Access Compliance Report Public Rights-of-Way (Curb Ramps)

Main Street: HEWES_ST Cross Street: BOND_AVE Location: SW

ADA ID: RPAT211027141603 Ramp Type: Type 1 - Perpendicular Diagonal Initial Pass/Fail: Pass Overall Compliance: No Severity Score: 4

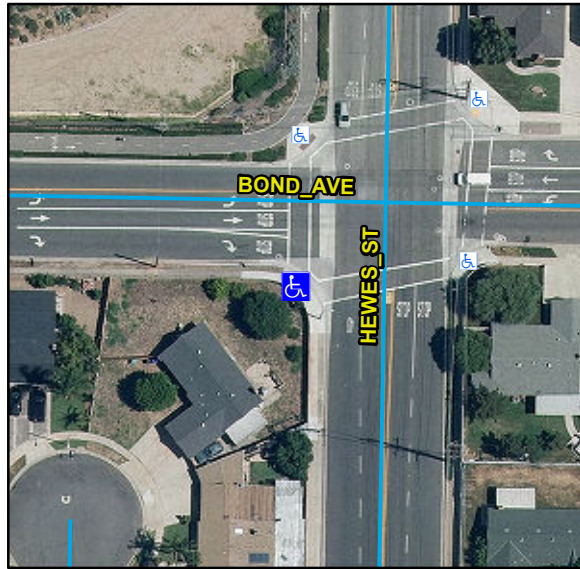
N/A	Ramp Inside Crosswalk 1	N/A	Yes	Ramp Inside Crosswalk 2	N/A
	Crossing 1 Slope (%)	6.3		Crossing 2 Slope (%)	0.2
	Crossing 1 Cross Slope (%)	0.6		Crossing 2 Cross Slope (%)	0.1
Yes	Gutter Ponding	No	No	Curb Slope	14.3
Yes	Gutter Lip Height (in)	0		Road Run Slope (%)	1.7
Yes	Gutter Run Slope (%)	3.6		Road Cross Slope (%)	1.5
No	Gutter Cross Slope (%)	2.3			
Yes	Overall Surface Condition: Acceptable		Yes	Perp Joint Present	Yes
	Cross Gutter Present?	Yes		Spandrel Present?	Yes
	Replace Cross Gutter?	No		Replace Spandrel?	No

Remove & Replace Curb Ramp With Two New Directional Ramps or Equivalent. Remove & Replace Gutter.
